ADDENDUM 2 – JOB 23335

TO: All prospective bidders on Projects NHU-SU-CPU-7-002(178)019, Job No. 23335 scheduled for the January 10, 2025 bid opening.

PLAN ADDENDUM SUMMARY AND APPROVAL

PROJECT INFORMATION		
Project:	NHU-SU-CPU-7-002(178)019	PCN: 23335
Location:	US-2 9 th Ave W to N of 34 th St in Williston	
Date:	12/27/2024	Lead Designer: Civil Science
Bid Opening Date:	1/10/2025	JOB#: 23335 Addendum#: 2

Revised 12/27/2024	STATE	PROJECT NO.	SECTION NO.	SHEET NO.
	ND	NHU-SU-CPU-7-002(178)019	60	1

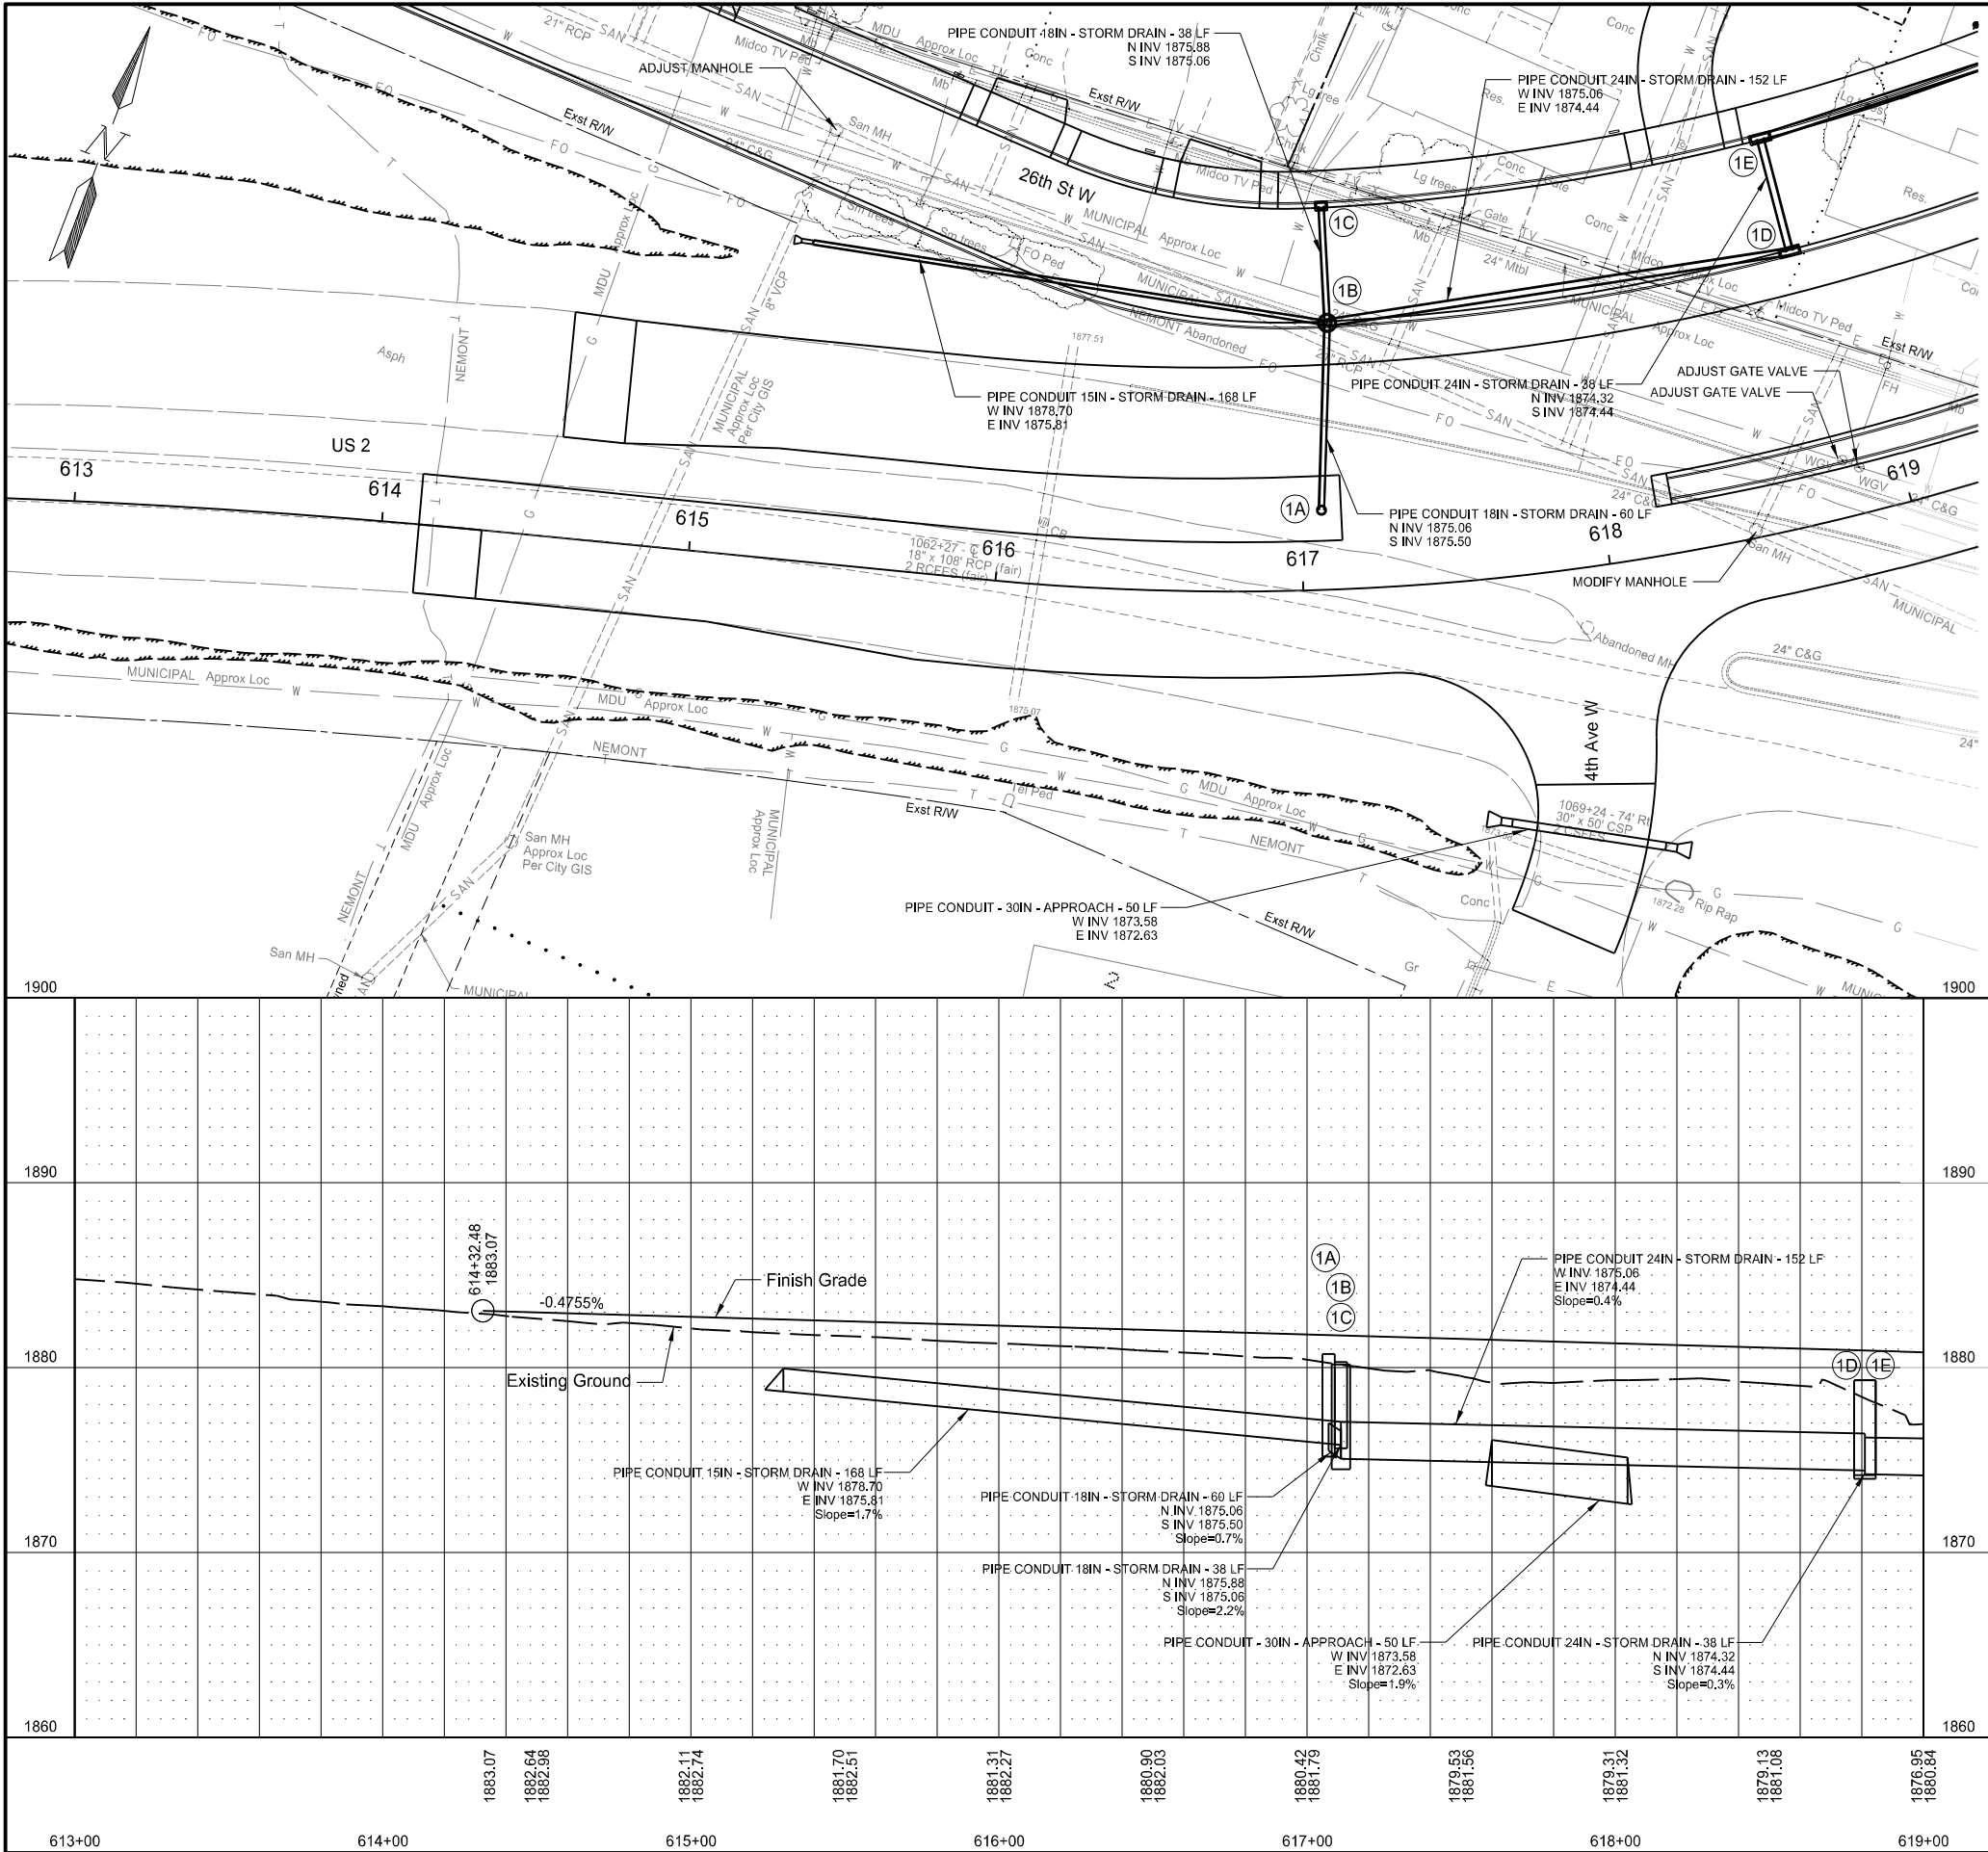
8	2	Revised quantity for 722 0317 MANHOLE CASTING TYPE 1 from 1 to 2 for Funding Source A. Total quantity was changed to 5.
8	4	Revised quantity for 910 0570 MODIFY MANHOLE from 2 to 1 for Funding Source B, and from 0 to 1 for Funding Source C. Total quantity was unchanged.
11	2	Revised quantities for 910 0570 Modify Manhole. Revised manhole at Sta 1019+81 to be included as part of Funding Source C.
60	1	Added bid item quantity for 722 0317 MANHOLE CASTING TYPE 1.

(C)		Sta 617+60 - 80' Rt to Sta 618+04 - 93' Rt	50	LF
722	0317	MANHOLE CASTING TYPE 1		
(A)		Sta 618+49 - 3' Lt	1	EA
722	3510	INLET - TYPE 2		
1C (C)		Sta 617+11 - 125' Lt	1	EA
722	3520	INLET - TYPE 2 DOUBLE		
1D (C)		Sta 618+81 - 88' Lt	1	EA
1E (C)		Sta 618+81 - 126' Lt	1	EA
		TOTAL	2	EA
722	3761	INLET SPECIAL-TYPE 2 60IN		
1B (C)		Sta 617+11 - 87' Lt	1	EA
722	4020	INLET CATCH BASIN 9IN BEEHIVE		
1A (A)		Sta 617+07 - 26' Lt	1	EA

Revised	12/27/2024	STATE	PROJECT NO.	SECTION NO.	SHEET NO.
		ND	NHU-SU-CPU-7-002(178)019	140	1

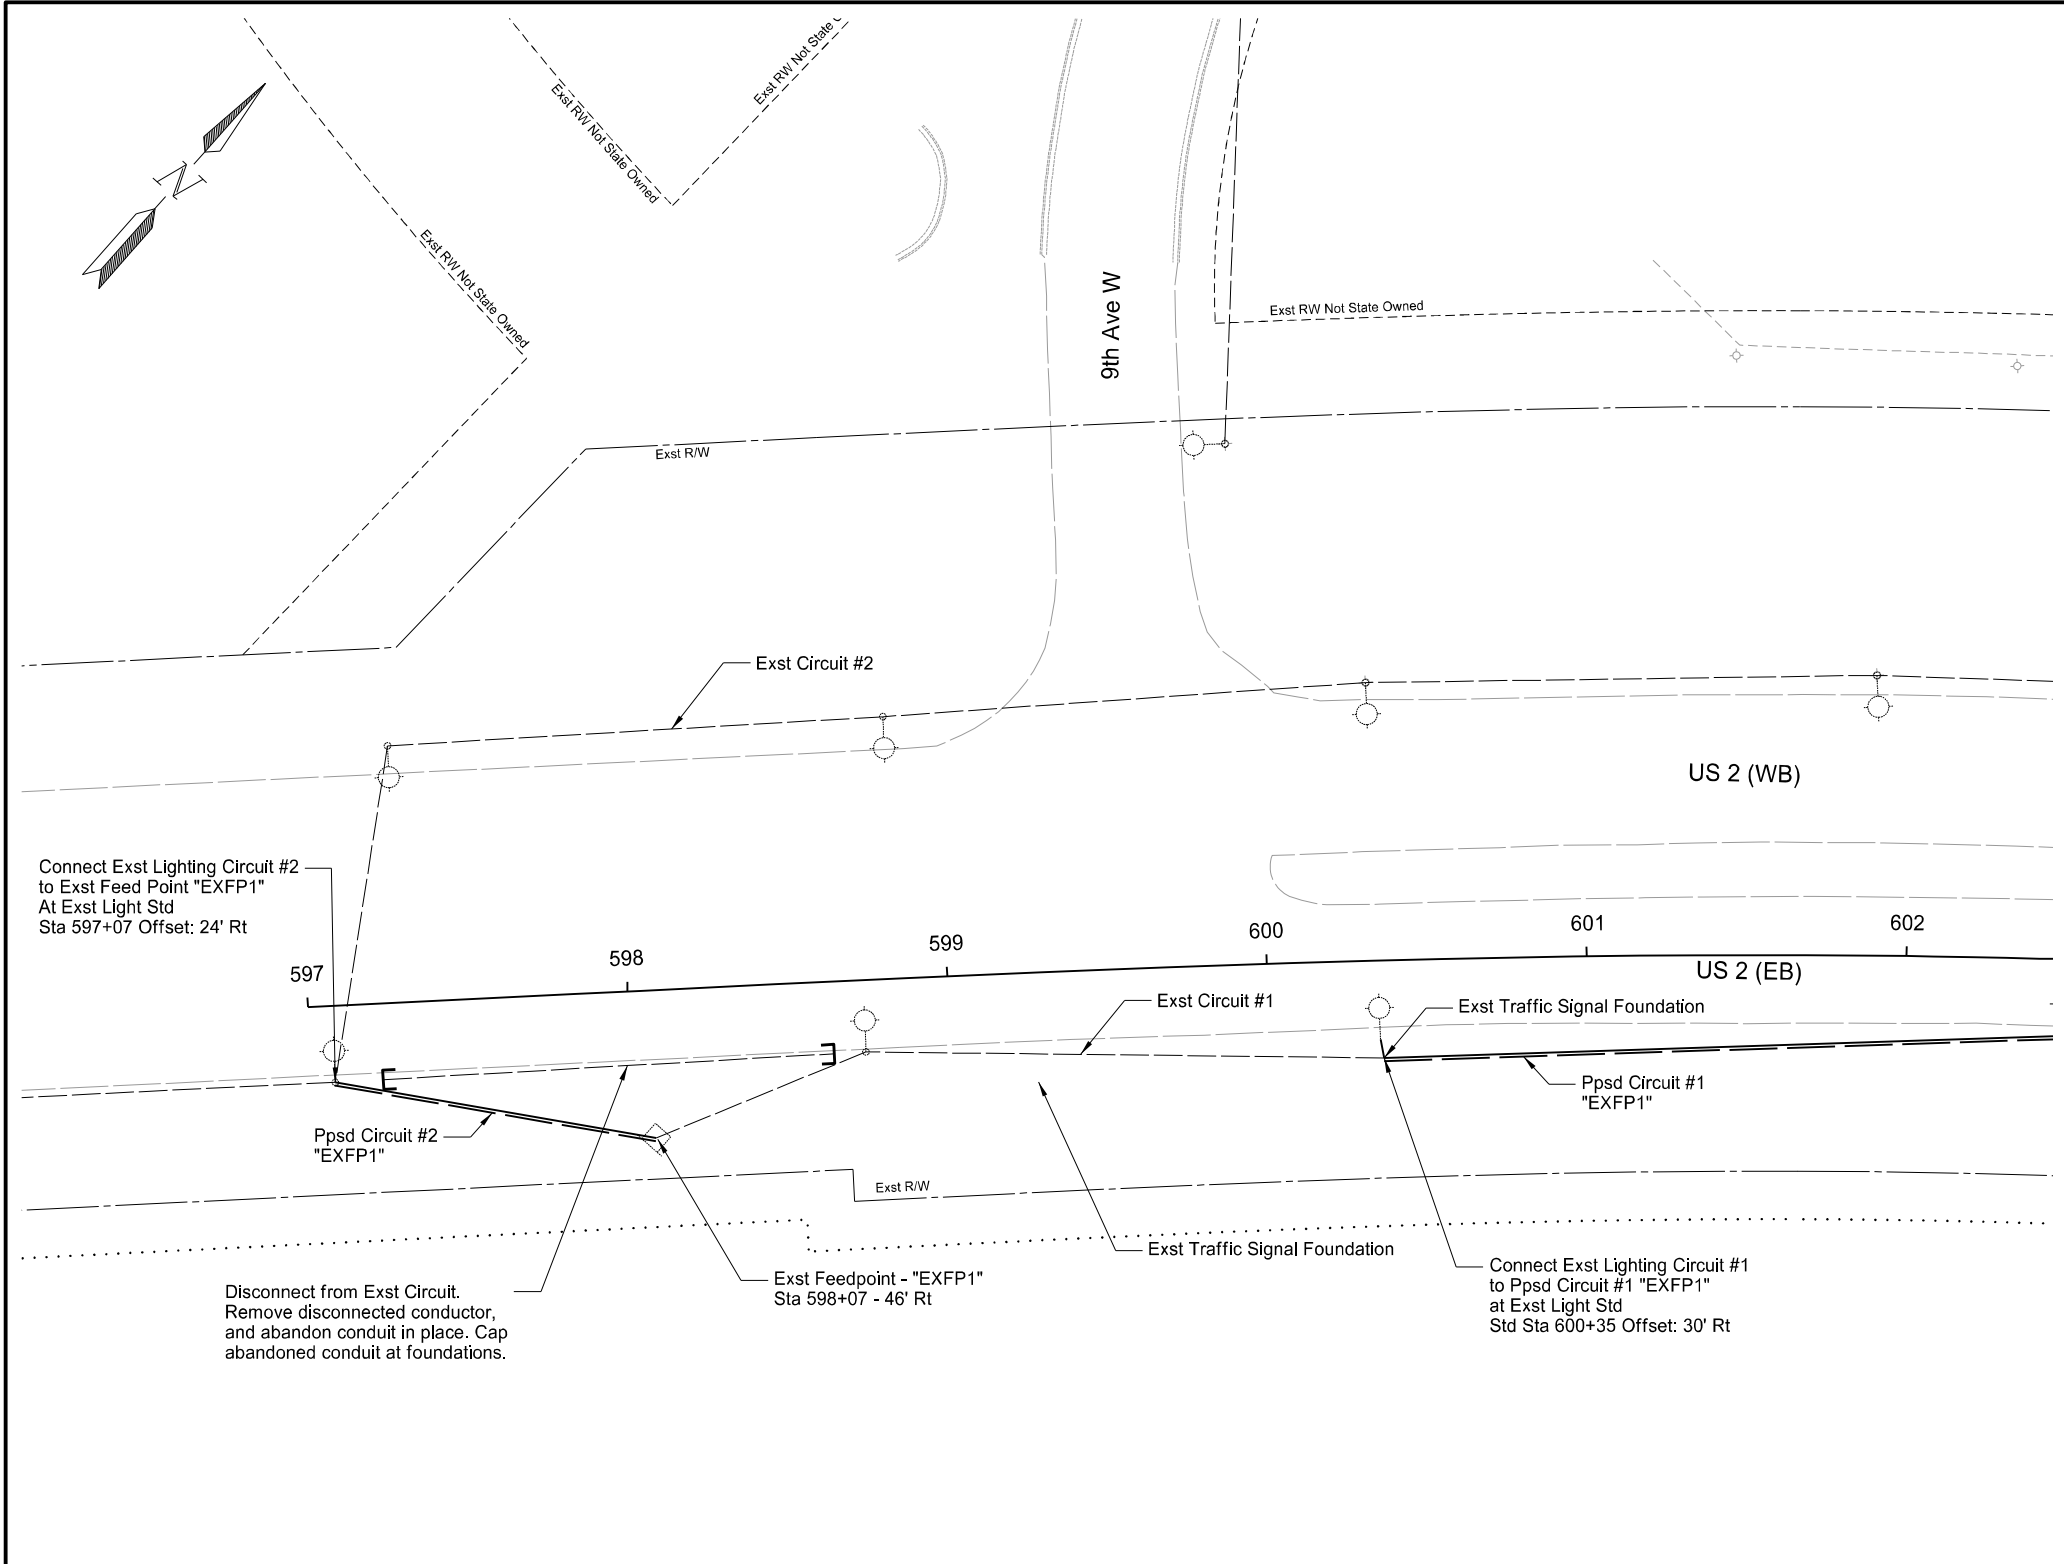
140	1	Proposed Circuit #3 was split into two circuits, Circuit 1 (south of US-2) and Circuit 2 (north of US-2). A new connection was added to the existing feed point EXFP1 from the existing luminaire at Sta 597+07. Proposed luminaires L1 to L8 were placed on Circuit 1 with a connection to the existing luminaire at Sta 600+35.
140	2	Proposed luminaires L9 to L-14 were placed on Circuit 2, with a connection to the existing luminaire at Sta 604+98. Pull boxes LHT-PB1, LHT-PB2 and the proposed crossing across US 2 were removed. Proposed circuit "Ppsd Circuit #3" name labels were revised to "Ppsd Circuit #1" south of US-2 and "Ppsd Circuit #2" north of US-2.
140	3	Proposed circuit "Ppsd Circuit #3" name labels were revised to "Ppsd Circuit #1" south of US-2 and "Ppsd Circuit #2" north of US-2.
140	4	Proposed circuit "Ppsd Circuit #3" name labels were revised to "Ppsd Circuit #1" south of US-2 and "Ppsd Circuit #2" north of US-2.

STATE	PROJECT NO.	SECTION NO.	SHEET NO.
ND	NHU-SU-CPU-7-002(178)019	140	16

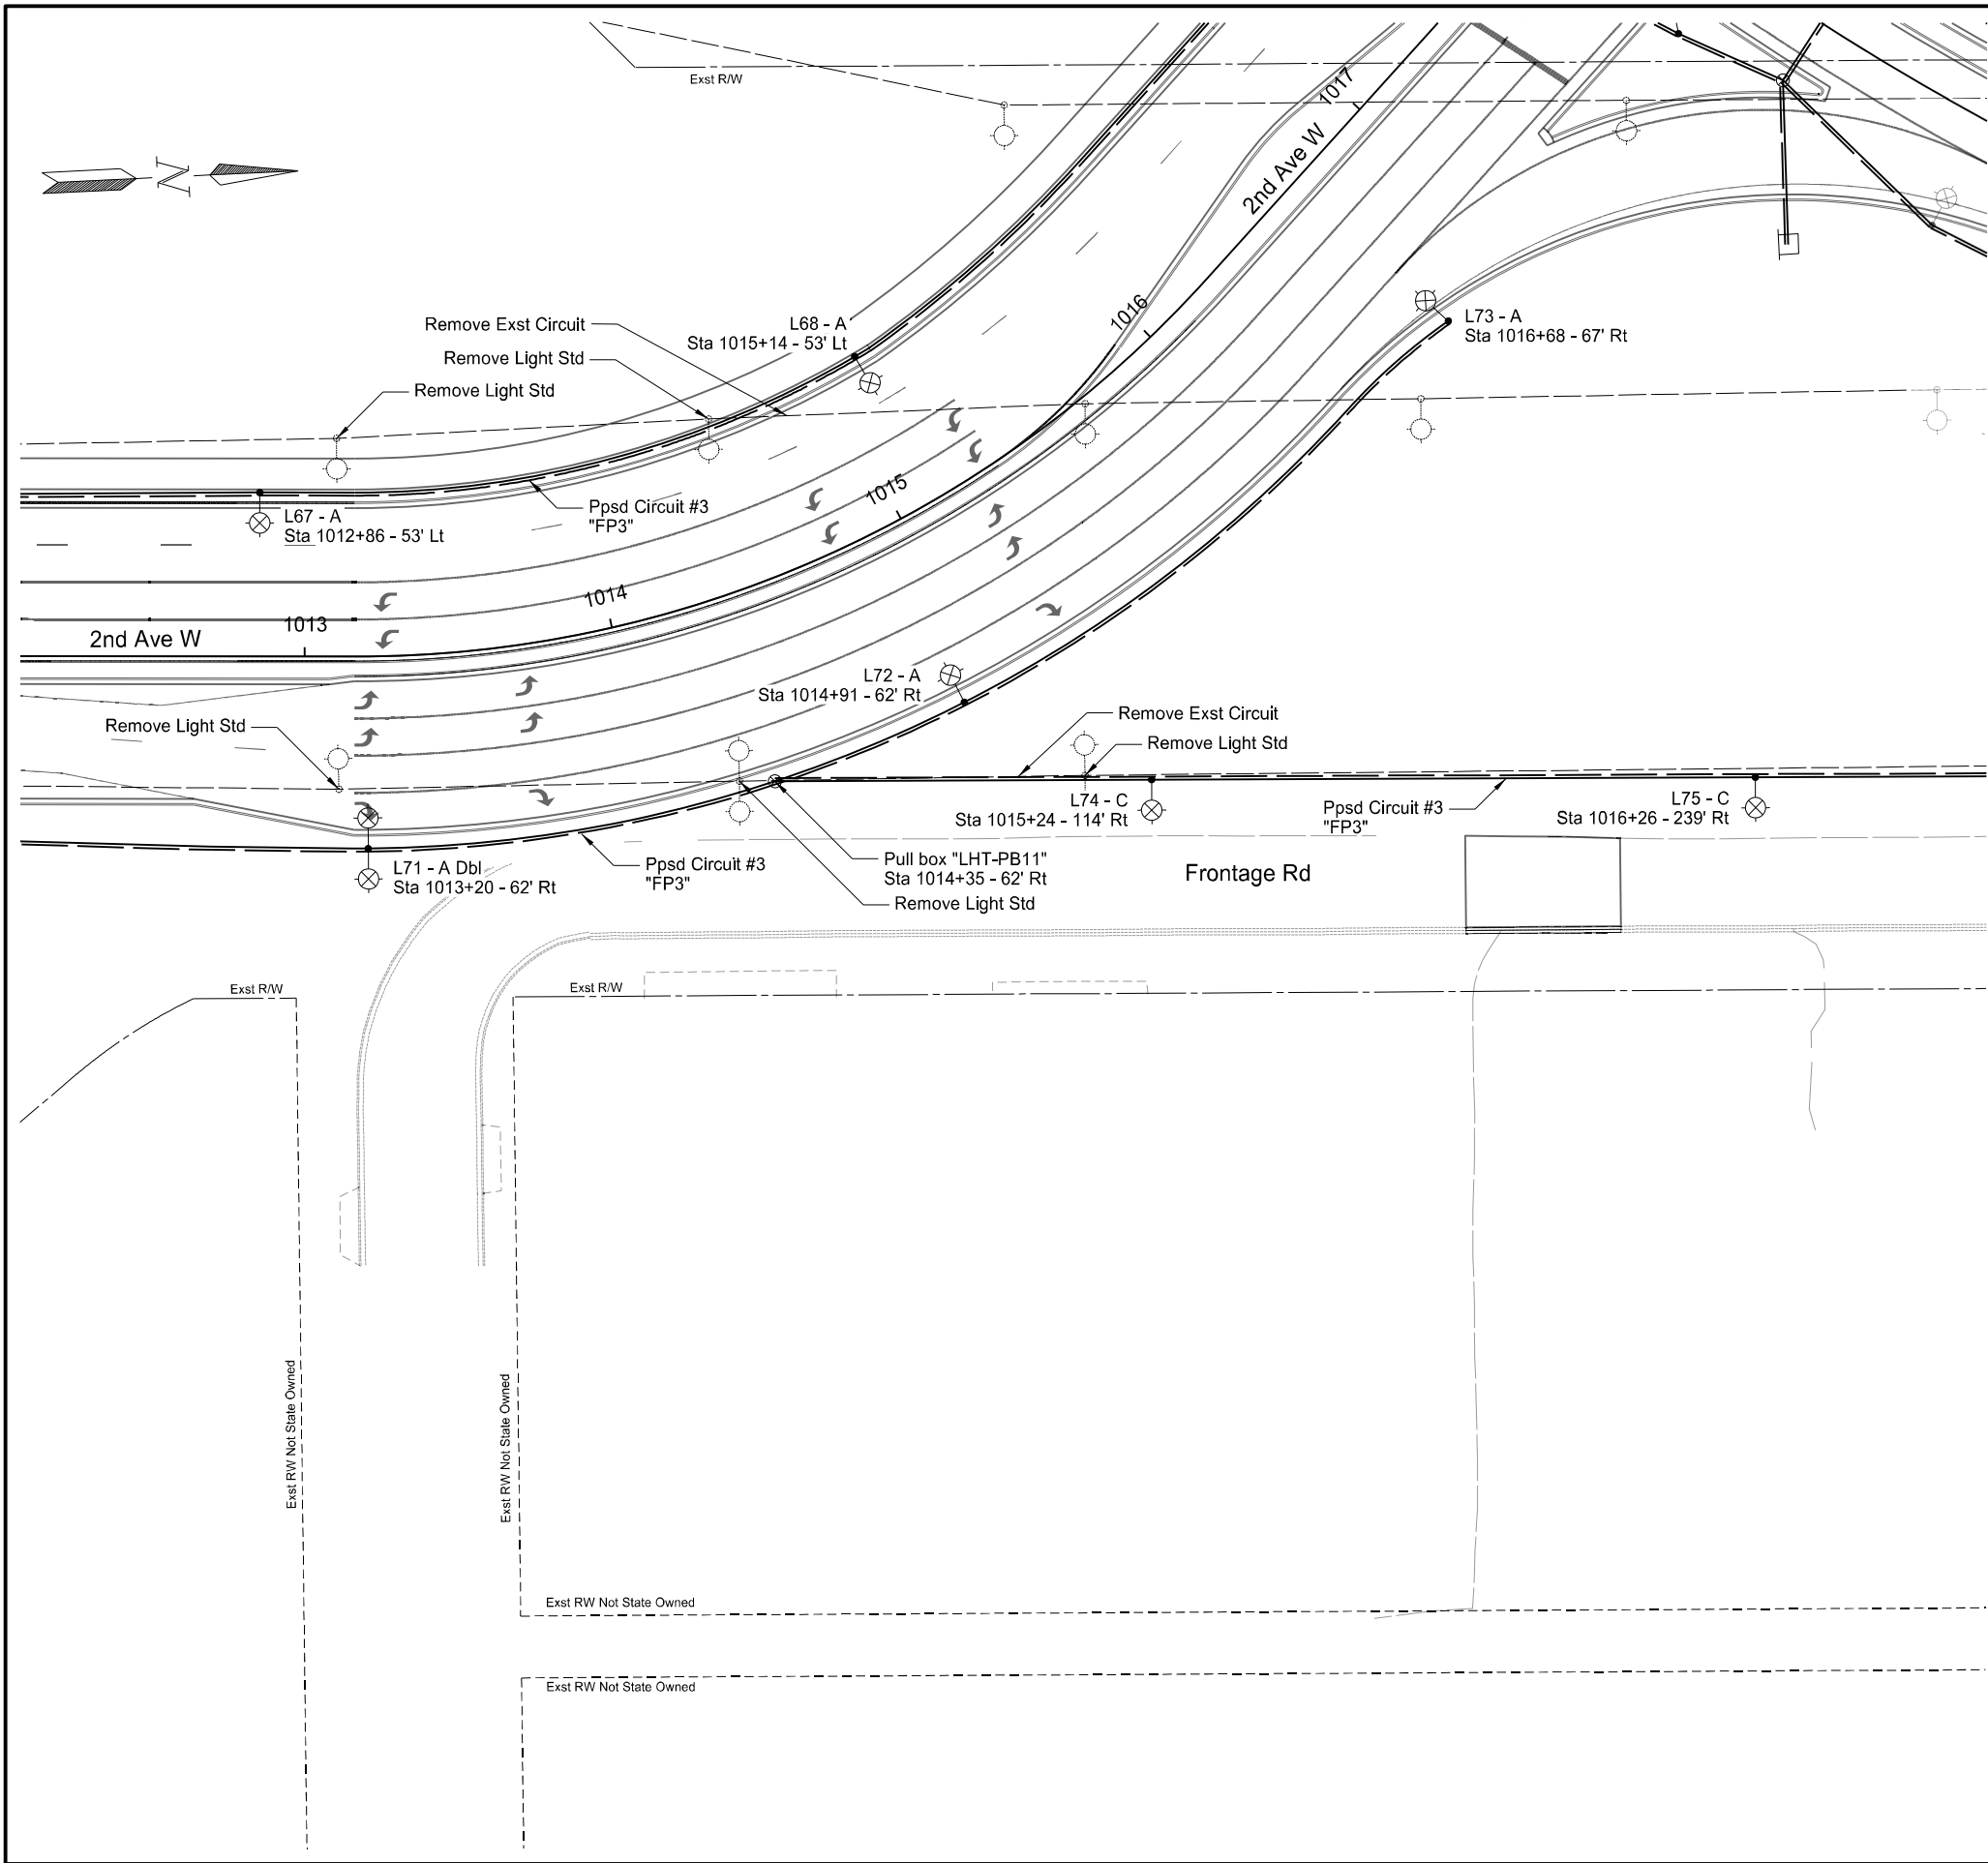
140	16	Revised Light Std L71 to a Type A Dbl.
140	20	Updated EXFP1 lighting schematic to show Ppsd Cirtcuit #1 including Luminaires L1 to L8, and Ppsd Cirtcuit # 2 including Ppsd luminaires L9 to L14.
140	23	Updated FP3 lighting schematic to show a Type A Dbl at Light Std L71.
140	24	Updated quantity table for Existing Feedpoint "EXFP1" at US-2 & 9 th Ave W based on revised circuit layout and removal of pull boxes LHT-PB1 and LHT-PB2.
140	26	Updated quantity tables for Proposed Feedpoint "FP3" at 2 nd Ave W & 26 th St W and Light Standard Locations Fed from FP3 at 2 nd Ave W & 26 th St W to show "L71-A" being revised to "L71-A Dbl". Updated lighting quantities summary table for the changes to "EXFP1" and the revision of L71 to a Type A Dbl. Removed quantities for Embedded Foundation. Total quantity for Concrete Foundation revised to 77.
150	6	Revised "Controller Type 1" in Quantities table to "ATC Controller and Cabinet". "Vide Detection Equipment" revised to "Video Detection Equipment".
